Review 2

**Shree Lakshmi Vardayini Urban Renewal, LLC**  
General Development Plan Amendment

Application P-24-003  
Harbor Station South Redevelopment Area (HS-2 District)  
Block 751, Lots 1.06, 1.07, 1.08, 1.09, 1.10, 1.12, 1.14, & 1.16

February 11, 2025

Figure 5. Proposed Alignment of West Constitution Ave

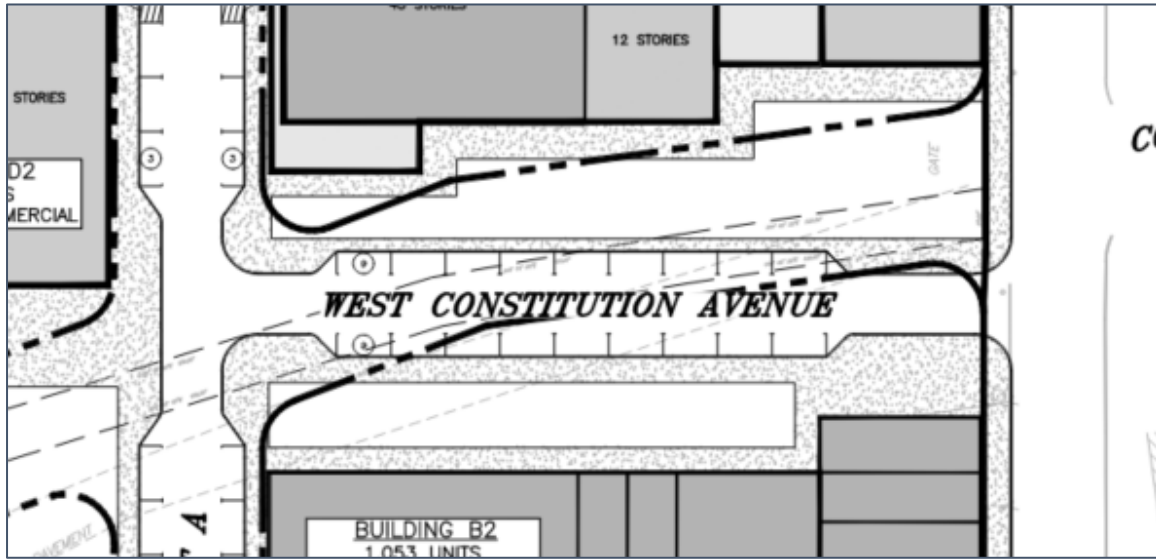
- 3-4. **Proposed Street Realignment.** The applicant proposes to realign the previously approved street grid on Lot 1.16. The approved street and lot lines followed the path of the sewer easement on Lot 1.16, whereas the proposed street is perpendicular to Flagship Street and overlaps Lot 1.06. Rectilinear pocket parks are proposed on both sides of West Constitution Avenue. Lot lines and rights-of-way will need to be reconfigured by subdivision to reflect the proposed layout of streets and open space when the first phase is proposed.

Figure 7. 3D Massing Diagram

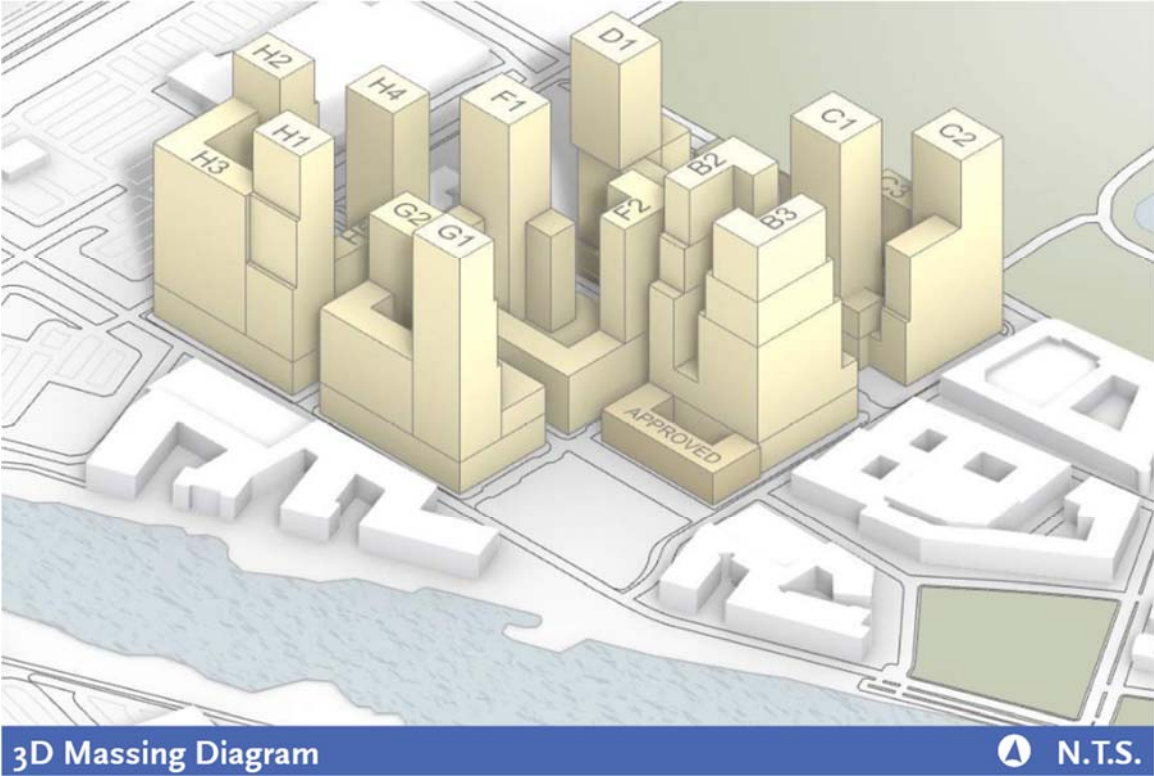
4.2.2. **Proposed Massing.** Proposed building massing is shown in the 3D diagram in Figure 7. The GDP amendment proposes high rise development on each block, including buildings that front existing or approved six-story buildings located on- and off-site. The massing of the buildings does not appear to relate contextually to the surrounding blocks within the Redevelopment Area. The proposed 50-story buildings front existing or approved 6-story buildings. **Step-backs should be provided on blocks within the amended GDP area where proposed high-rise buildings front lower-density buildings to provide a visually cohesive architectural design throughout the Redevelopment Area. Perspective renderings of the streets that bound the GDP area (Goldsborough Drive, Chosin Few Way, and Flagship Street) are recommended to demonstrate the visual relationship between the proposed buildings and existing neighboring development.**
